SITE PLAN
SLIM CHICKENS
SVC OF S. PARKER ROAD AND E. PINE LANE, PARKER, CO 80134
SITE PLAN

C1.0

UTILITY PLAN

C3.0

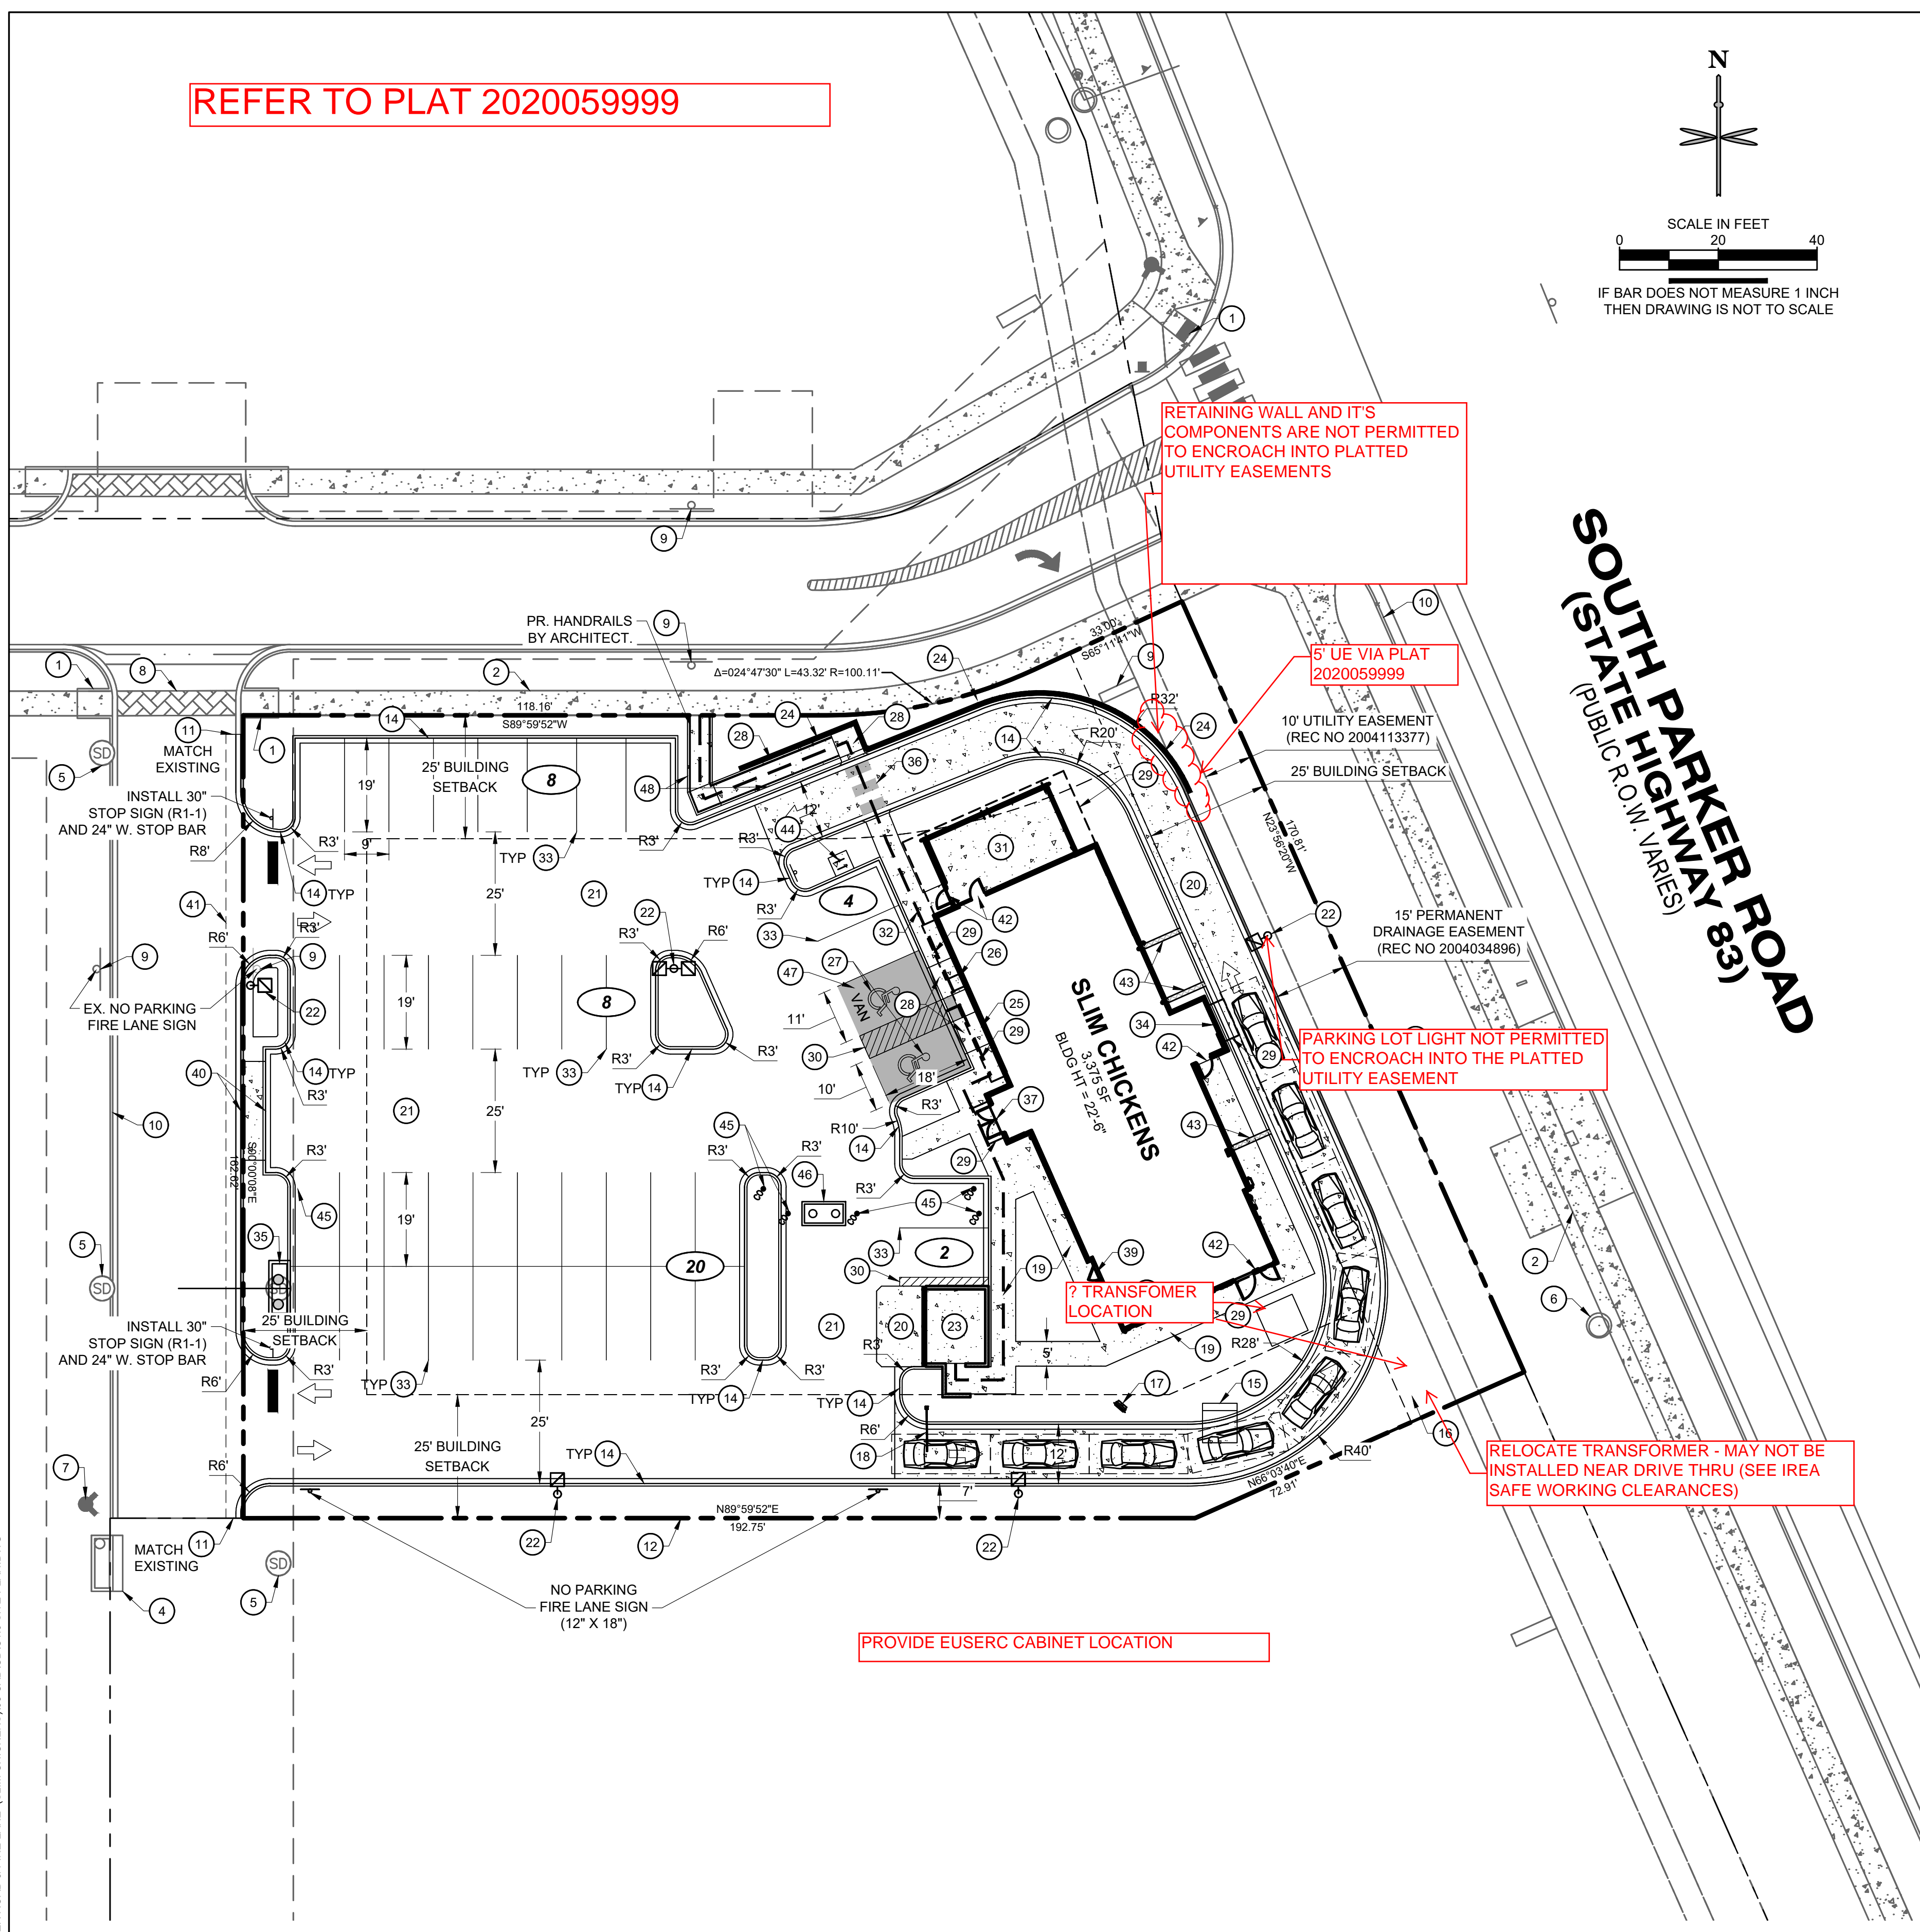
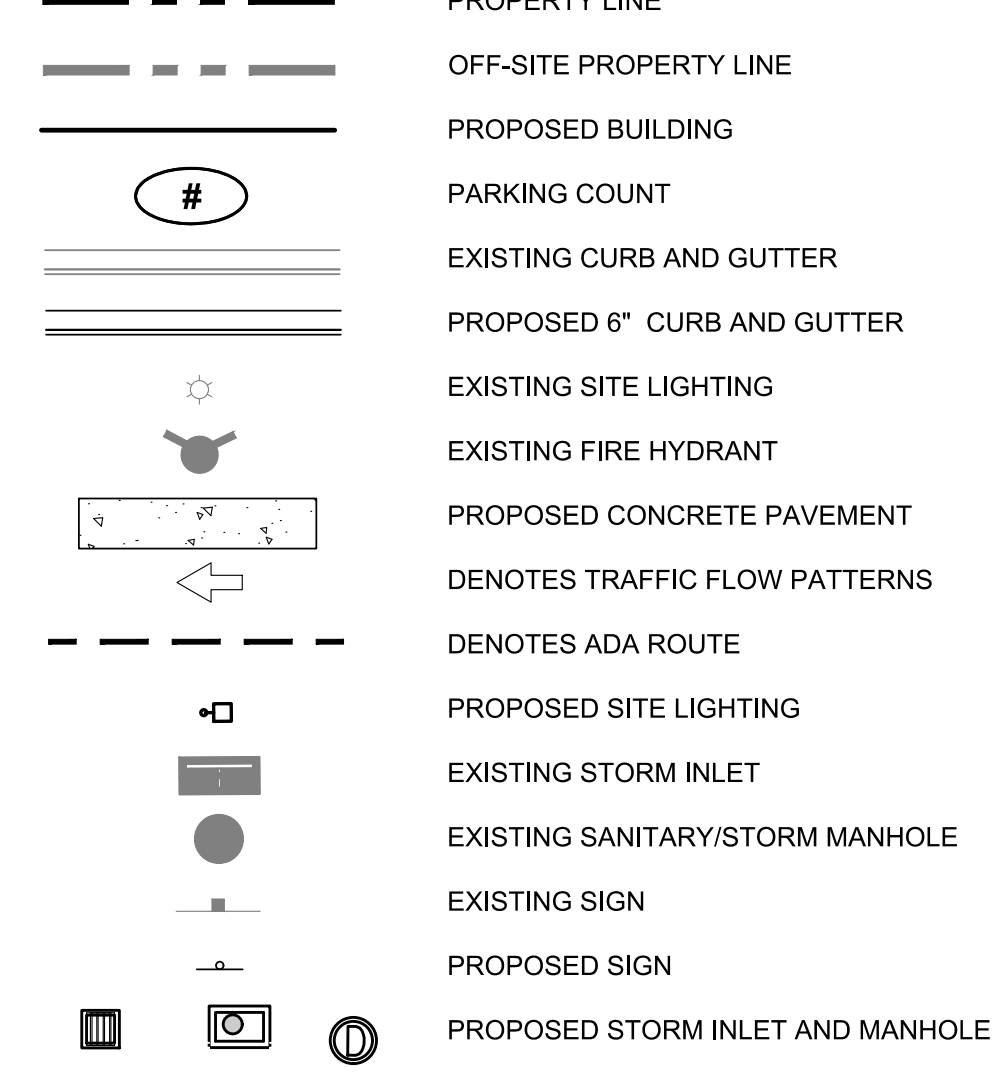
RETAINING WALL AND IT'S COMPONENTS ARE NOT PERMITTED TO ENCRACH INTO PLATTED UTILITY EASEMENTS

PARKING LOT LIGHT NOT PERMITTED TO ENCRACH INTO THE PLATTED UTILITY EASEMENT

RELOCATE TRANSFORMER - MAY NOT BE INSTALLED NEAR DRIVE THRU (SEE IREA SAFE WORKING CLEARANCES)

PROVIDE EUSERC CABINET LOCATION
